Proposal for the 09 Series of Amendments to UN Regulation No. 16 (Safety-belts) *

Submitted by the expert from the Netherlands

The text reproduced below was prepared by the Ad Hoc Group on Child Restraint Systems to introduce definitions, requirements and a test procedure for lower tether anchorages. The modifications to the existing text of the UN Regulation by document ECE/TRANS/WP.29/GRSP/2023/9 are marked in “bold black“ for new or strikethrough for deleted characters. The modifications made by this document are marked in “(bold) blue” for new or strikethrough for deleted characters.

2. Arrangements of the safety-belt approval marks (see paragraph 5.3.5. of this Regulation)

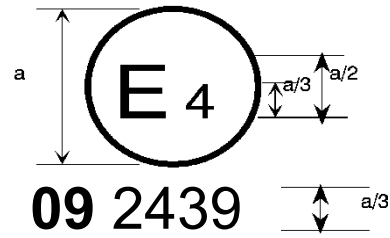
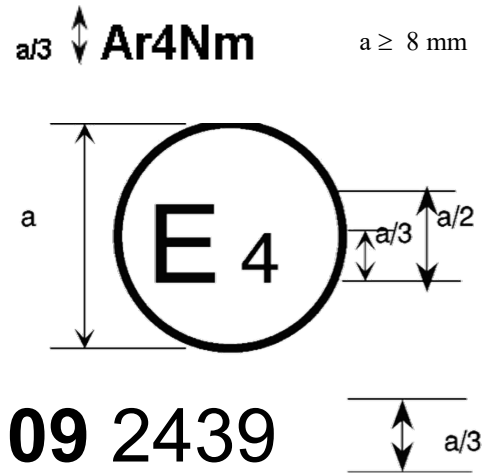
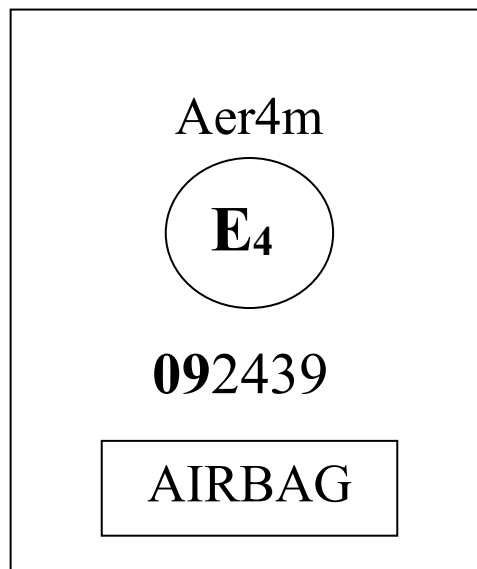
The belt ... the 06, 07, ~~08~~ or **09** series of amendments at the time of approval.

The belt ... 06, 07, ~~08~~ or **09** series of amendments at the time of approval.

The belt bearing ... the 06, 07, ~~08~~ or **09** series of amendments at the time of approval.

The belt ... the 06, 07, ~~08~~ or **09** series of amendments at the time of approval.

The belt ... the 06, 07, ~~08~~ or 09 series of amendments at the time of approval. This belt shall not be fitted to vehicles of category M₁.

The ... 06, 07, ~~08~~ or 09 series of amendments at the time of the approval. This safety-belt has to be fitted to a vehicle equipped with an airbag in the given seating position."
